DESCRIPTIVE REPORT

DESCRIPTIVE REPORT TO ACCOMPANY
HYDROGRAPHIC SURVEY H-8794 (PE-10-1-64)

NORFOLK HYDROGRAPHIC PROCESSING BRANCH
ADDENDUM
To Accompany

HYDROGRAPHIC SURVEY REVIEW

TO ACCOMPANY
 PE-10-1-64 H-8794
 Pos. 1st-77c, 80c-85c, 88c-103c
 launch #2
 July 8, 1964

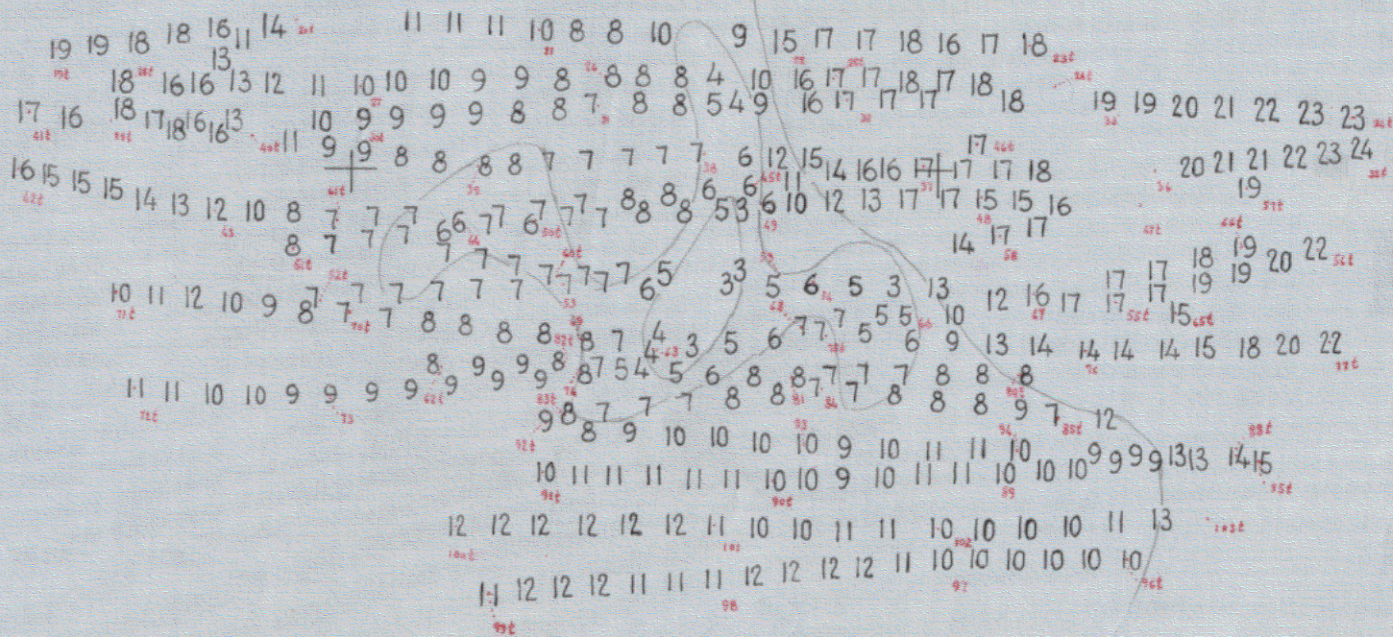
The following positions are being submitted on a smooth overlay as none were used on the smooth sheet because of extremely weak fixes. The area concerned is adequately developed, mostly with lines controlled by Hi-Fix. ✓

in DR.
Depth on overlay generally deeper

Positions 19 to 77t, 80 to 85t and 88 to 103t (red)
